CHANGE ORDER APPROVAL FORM

PROJECT: Nassau County Transportation Center

CHANGE ORDER NUMBER: 01

PROPOSAL REQUEST

A2

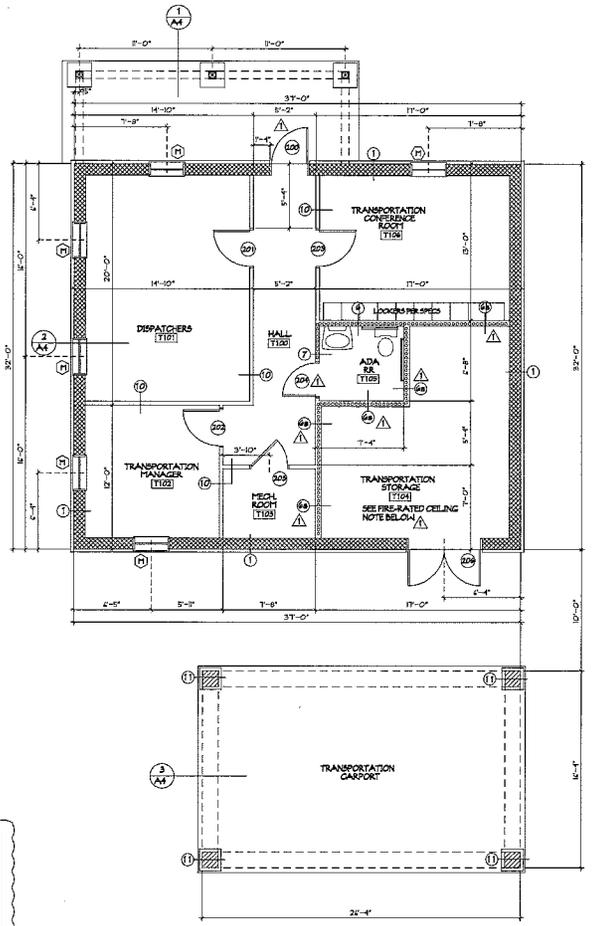
- 1) Revised Wall Assembly around perimeter of Transportation Storage Room T104 to 1-hour fire-rated assembly per UL # U-465. See revised wall assembly legend and plan notes.
- 2) Revised Ceiling Assembly above Transportation Storage Room T104 to 1-hour fire-rated assembly per UL # L-524. See ceiling assembly notes.
- 3) Revised door swings for door numbers 200 and 204.

FIRE-RATED CEILING NOTE
ROOM T104: ONE-HOUR FIRE-RATED CEILING ASSEMBLY
PROVIDE ONE-HOUR FIRE-RATED CEILING ASSEMBLY
PER WALL ASSEMBLY # U-465.
3/4" 1/2" GPLY-WOOD SUB-FLOOR ON 1" METAL LISTS
AT 24" O.C. MAX. W/ (2) 1/2" LAYERS 1/2" TYPE X
GLASS. SET BOTTOM OF LISTS AT 7'-0" ABOVE SLAB.
REMARK: THAT CEILING ASSEMBLY TO BE
INSTALLED AFTER INSTALLATION OF FIRE-RATED
GLASS AT WALL ASSEMBLY PER WALL TYPE 66.
